NOTICE OF DECISION

DECISION OF THE PLANNING COMMISSION

**CLASS 3 DESIGN REVIEW / CLASS 3 SITE PLAN REVIEW / CLASS 2
ADJUSTMENT CASE NO.: DR-SPR-ADJ19-10**

SUMMARY: Proposed three story mixed-use multi-family and retail development on a vacant portion of the site, and maintaining an existing parking lot and driveways.

ARCHITECTURAL
SITE PLAN

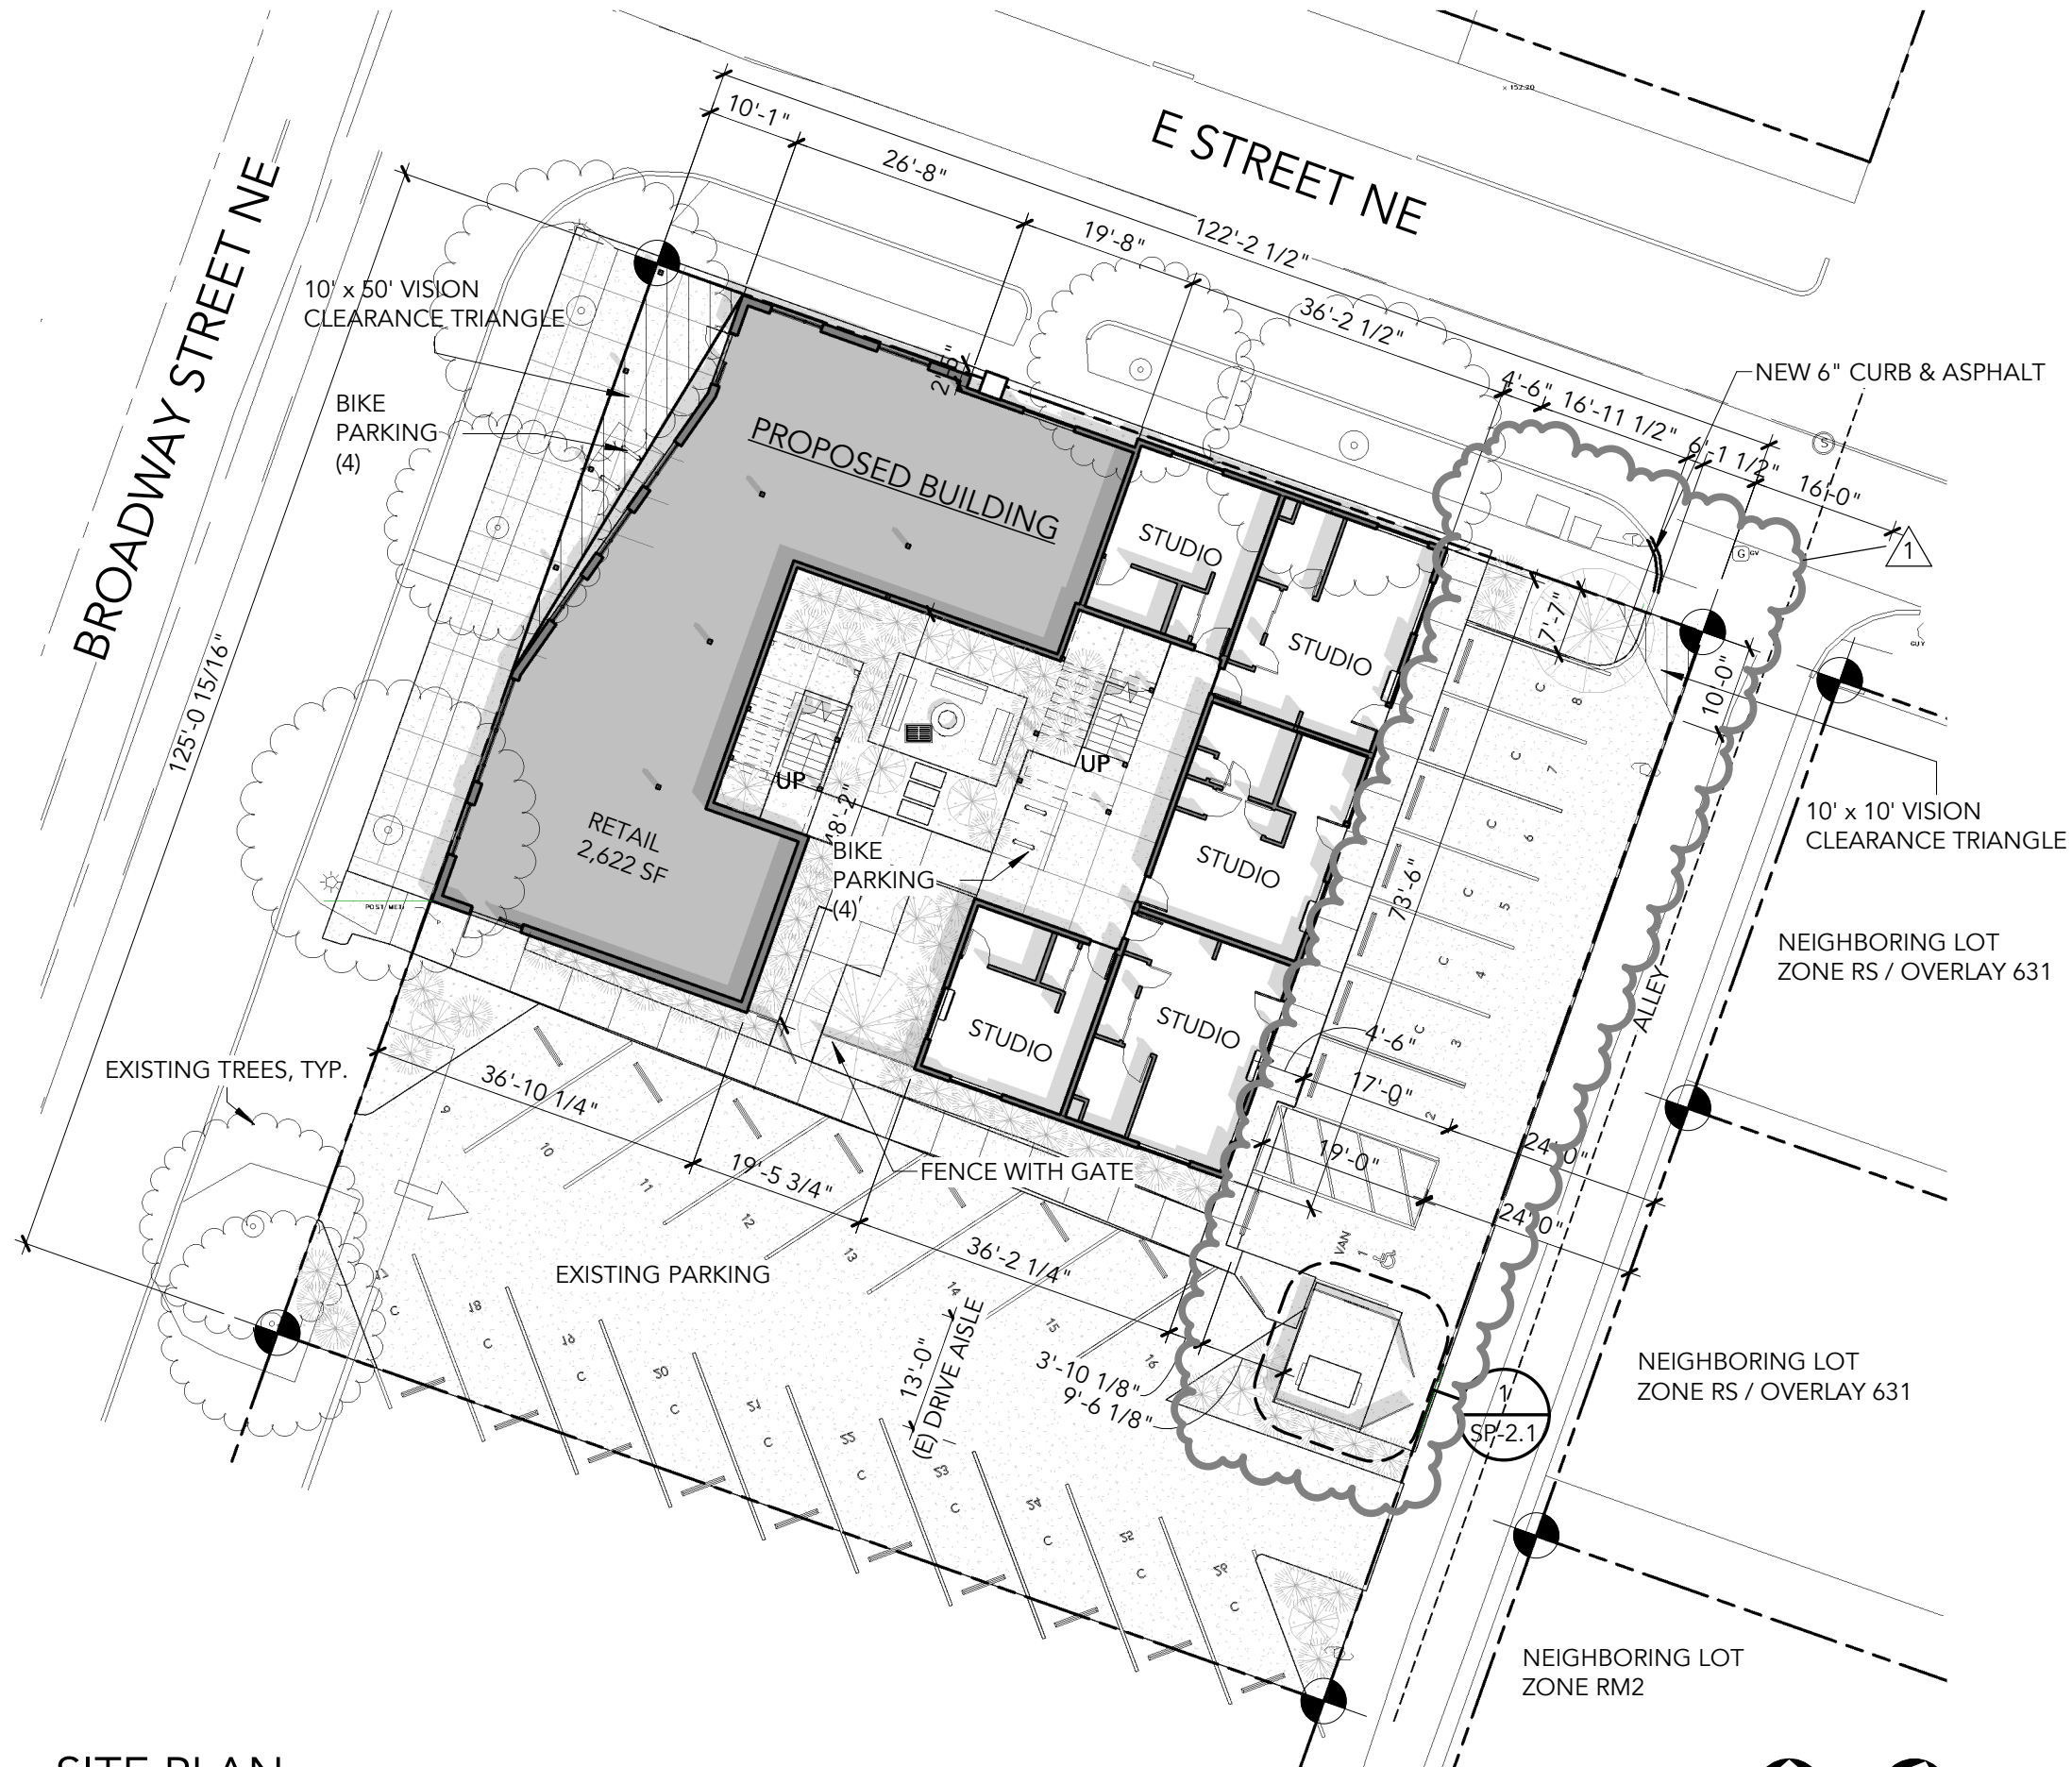
The proposed plan shows awnings encroaching into the right-of-way. The applicant shall obtain awning permits.

The proposed plan also shows bicycle parking spaces within the vision clearance triangle. The bicycle parking shall comply with SRC Chapter 805.

The existing alley approach along E Street does not meet PWDS. Pursuant to SRC 803.040, the applicant shall be required to replace the existing alley approach along E Street NE pursuant to PWDS.

The existing off-street parking area does not have a setback provided adjacent to Broadway Street NE, SRC Chapter 806 requires a minimum 6-10 foot vehicle use area setback. The proposed development will remove an existing parking space adjacent to Broadway Street NE and add a new triangular landscape island in its place. While the new landscaping area does not comply with the minimum setback, a combination of trees and shrubs will be used to add additional screening of the off-street parking that wasn't previously provided. The requested adjustment allows the existing off-street parking area to be utilized for the proposed development and helps to maintain an adequate number of off-street parking spaces for future uses.

The existing parking lot does not currently provide a setback to the neighboring parking lot to the south, and the development site cannot easily accommodate the required setback without significantly reducing the amount of off-street parking spaces. The requested adjustment allows the existing condition of the off-street parking area, and neighboring area to remain.

Condition 2: Obtain awning permits for proposed awnings encroaching into the right-of-way.

Condition 3: Proposed bicycle parking within the vision clearance triangle shall comply with SRC Chapter 805.

Condition 4: Replace the existing alley approach along E Street NE pursuant to Public Works Design Standards.

1 TRASH ENCLOSURE
SCALE: 1/4" = 1'-0"

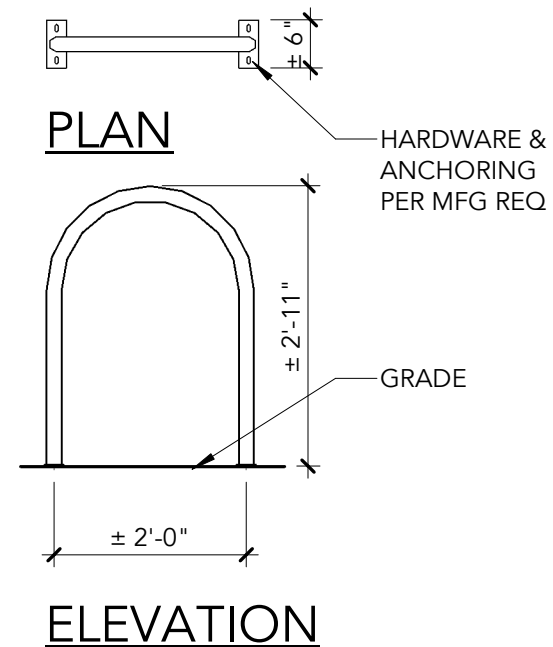
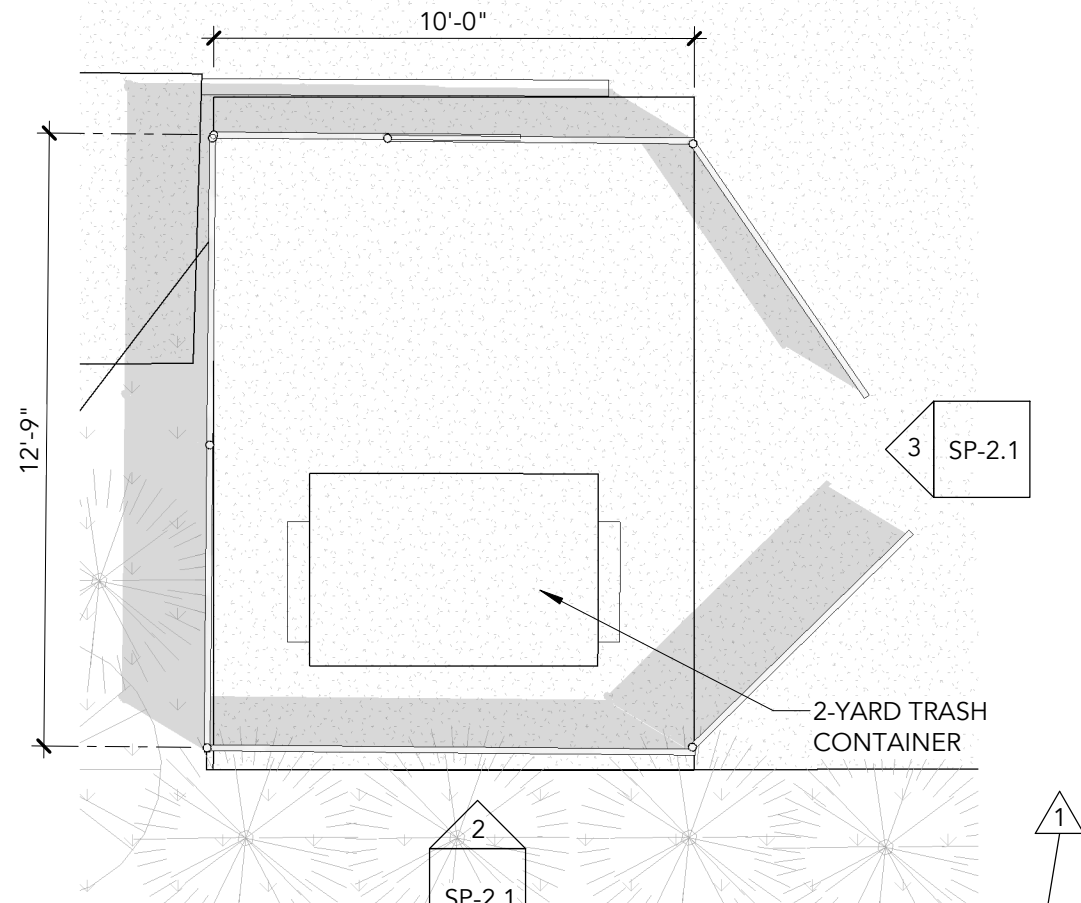
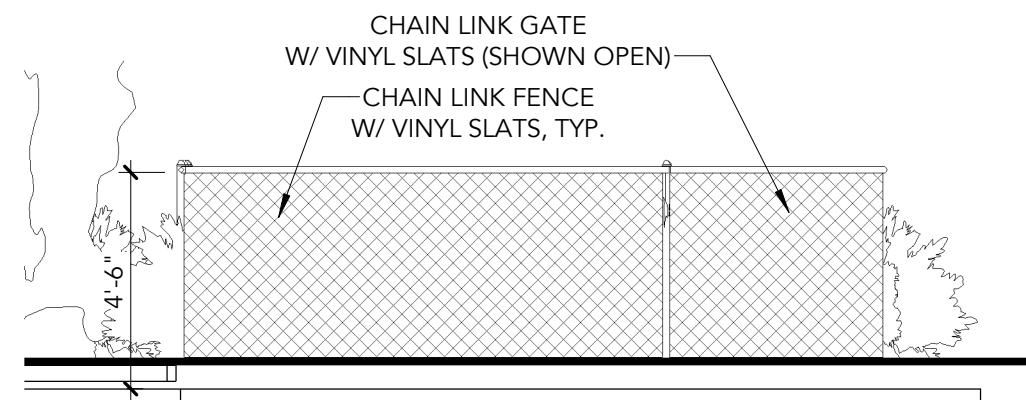
Finding: The site plan indicates that a new solid waste enclosure with receptacles 2 cubic yards in size is proposed.

Finding: The design and materials for the slab is not indicated in the proposed plans, but will be reviewed for conformance with this development standard at the time of building permit review.

Finding: The proposed site plan indicates that the enclosure walls will be chainlink with privacy slats. A bumper curb 12 inches inside the perimeter of the enclosure walls is required, however the curb is not indicated on the proposed plans.

Condition 1: Development of the solid waste service area shall conform to all applicable standards of SRC Chapter 800.

LANDSCAPE
PLAN

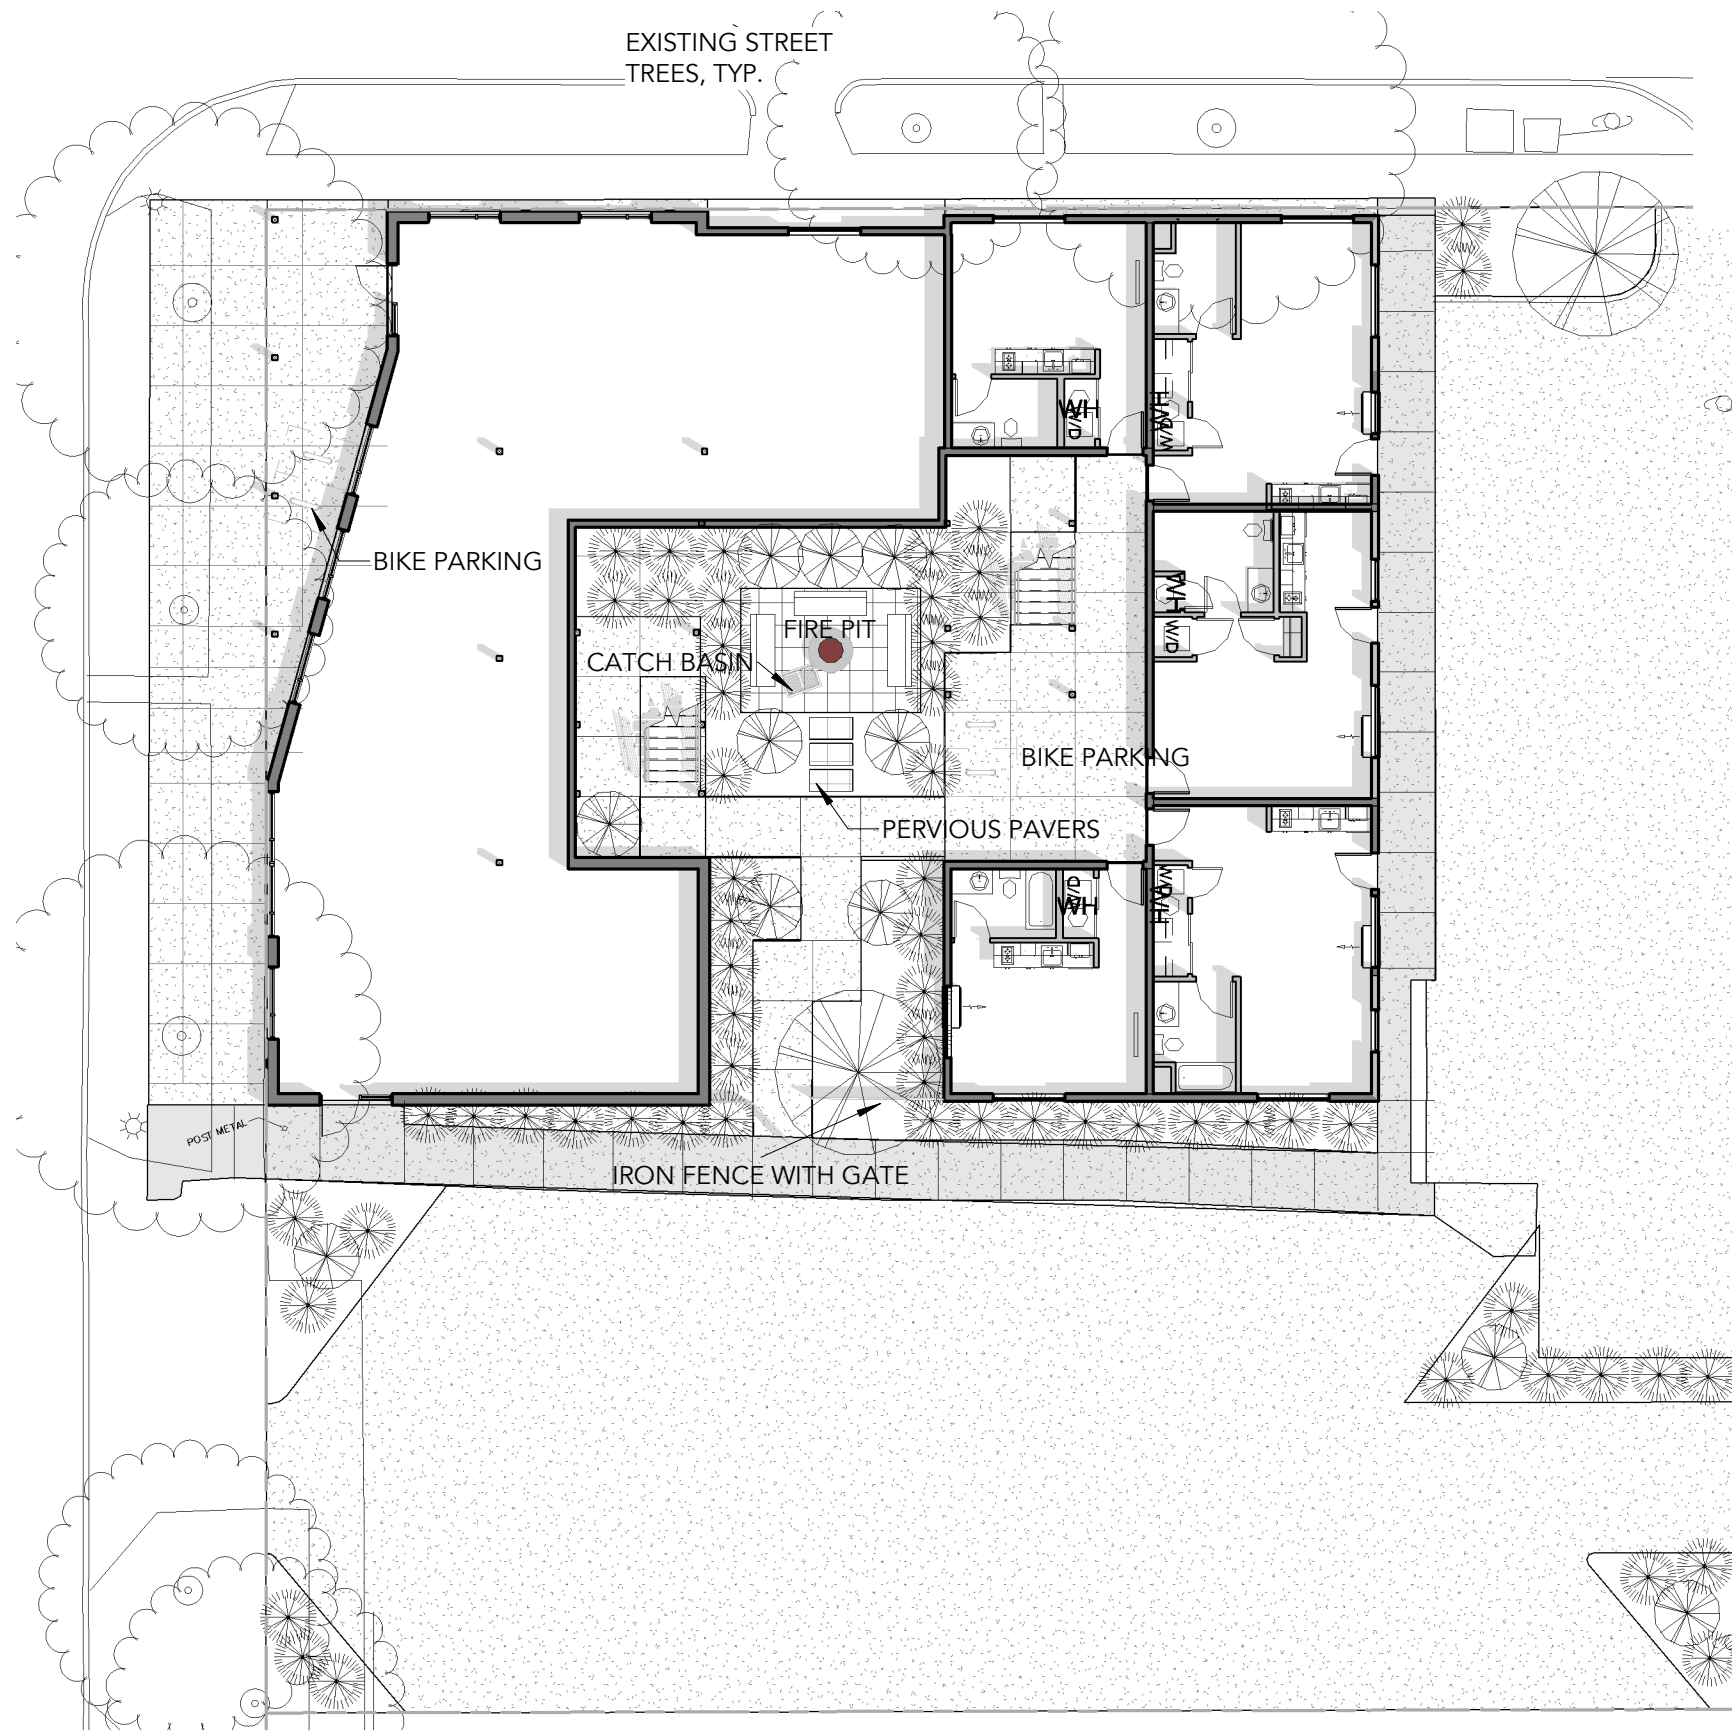
Finding: The proposed site plan indicates that approximately 1,774 square feet of landscaping is provided for the development site. However, as conditioned a minimum of 115 plant units are required for the proposed development. Of the required plant units, a minimum of 46 plant units shall be a combination of mature trees, shade tree, evergreen/conifer trees, or ornamental trees ($115 \times 0.4 = 46$).

The proposed site plan indicates that 1,774 square feet of landscape area will be provided, approximately 11 percent of the development site. The applicant indicates that the full amount of landscape cannot be provided due to the limited size of the property, the need to keep the existing off-street parking area and other development requirements. Staff recommends a condition of approval requiring a minimum of 115 plant units be incorporated into the landscape design, the same number of plant units that would be required if the full amount of landscape area had been provided ($2,292 / 20 = 114.6$). As conditioned, the purpose of the standard is equally or better met.

Condition 8: A minimum of 115 plant units shall be incorporated into the landscape design.
